SCHWEIZER SERVICE BULLETIN

B-249
20 Mar 1992

SUBJECT: ONE-TIME INSPECTION OF THROTTLE OVERRIDE BELLCRANK ASSEMBLY

MODELS AFFECTED: Model 269C Helicopters S/N 1166 through 1543

Figure B-249-1. Throttle Override Bellcrank Assembly.

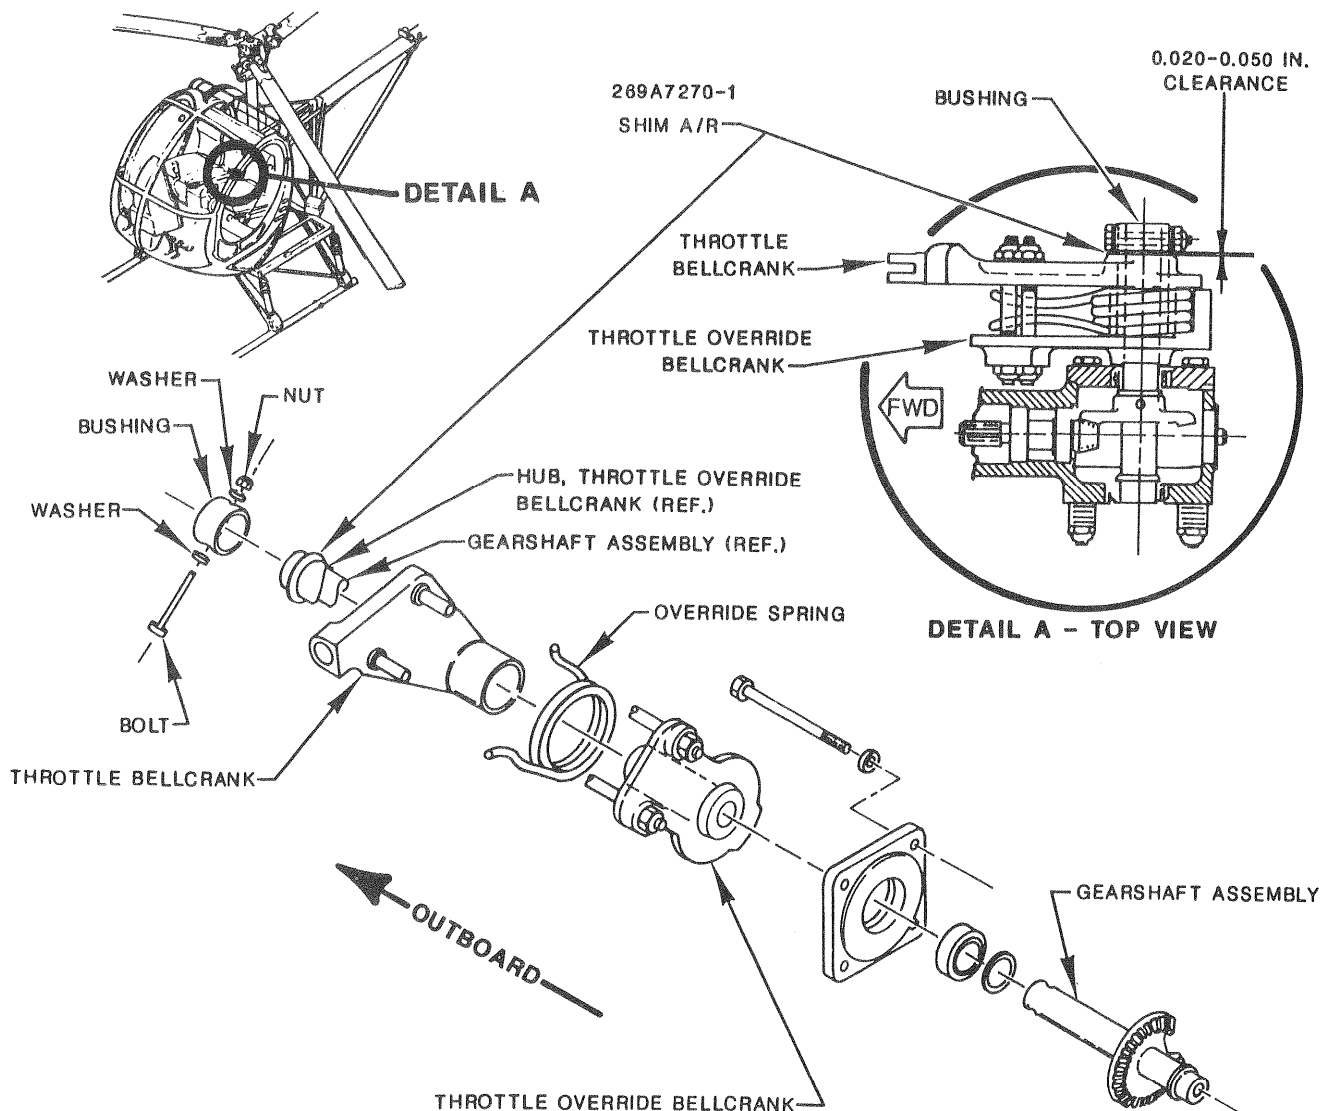
PREFACE: There is a possibility that the throttle bellcrank may have excessive lateral movement on the hub of the throttle override bellcrank. This Service Bulletin provides a one-time inspection to check for this condition, and subsequent corrective action if required.

Excessive lateral movement may allow the override spring (located between the bellcranks) to slip past the bellcrank pins, resulting in loss of throttle control. This condition could lead to a loss of control of the helicopter and subsequent serious injury, death and/or property damage.

- a. Gain access to throttle bellcrank area.
- b. Push inboard on throttle bellcrank (Figure B-249-1) and verify that it is in solid contact with throttle override bellcrank. Using a feeler gage or similar tool, inspect for 0.020 to 0.050 inch clearance between throttle bellcrank and bushing, as shown on Figure B-249-1, Detail A.

- d. If clearance (step b.) is greater than 0.050 inch, install shim(s) at outboard end of throttle bellcrank, in accordance with the following:
 - (1) Calculate the number of .020 inch shims (P/N 269A7270-1) necessary to reduce the clearance to 0.020 to 0.050 inch.

- (4) Using the data from step (1), install 269A7270-1 shim(s) at outboard end of throttle bellcrank, as shown on Figure B-249-1.

- c. If clearance (step b.) is within specified tolerance, the requirements of this Service Bulletin are satisfied. Reinstall all parts removed to gain access, and record compliance in accordance with step f.

- (5) Align holes and reinstall bushing, bolt, washers and nut on gearshaft assembly. Ensure that bushing, bolt and gearshaft assembly are oriented in original position.
 - (6) Verify that clearance between throttle bellcrank and bushing is correct, as specified in step b.
 - (7) Operate throttle through entire range of override (in both directions) to verify correct operation of override assembly.
- e. Reinstall all parts removed to gain access.
- f. Record compliance with this Service Bulletin in the aircraft records.
